PRODUCT BULLETIN # 20643Generic Copy

Issue Date: 15-Sep-2014**TITLE:** Change in carrier tape design for WLP6J from without pocket hole to with pocket hole.**PROPOSED FIRST SHIP DATE:** 01-Oct-2014**AFFECTED CHANGE CATEGORY(S):** Packing material**FOR ANY QUESTIONS CONCERNING THIS NOTIFICATION:**

CHANGE POINT

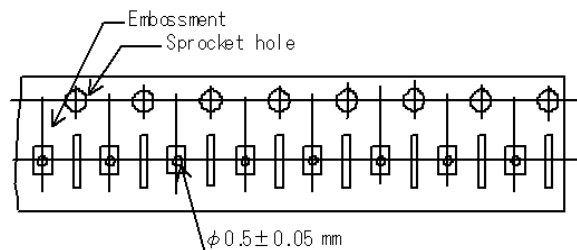
This change is addition of the hole to the emboss carrier tape pocket.
There is no change to raw materials and pocket size.
* Detail: Refer to below carrier tape drawing.
